SERVICE INFORMATION

FROM: SERVICE DEPARTMENT
Cab 120634
For Tractors EGT 120 - 150

DATE: March 1, 1974 **NO:** D 74-15-2
Mounting Bracket for Spout
Control Arm on Snow Blowers

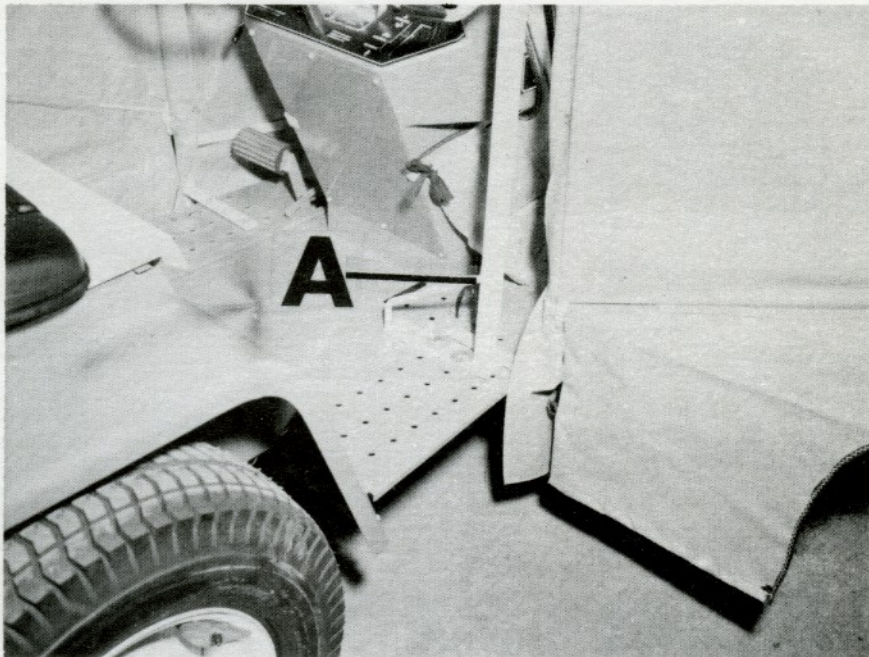
When the snow thrower is mounted on an EGT 120 - 150 tractor in conjunction with the cab, it will be necessary to move the spout control mounting bracket "A" in one hole on the floor as shown in above photo. The mounting bracket support which mounts underneath the floor platform cannot be used in this application. Replace support with two (2) flat washers.
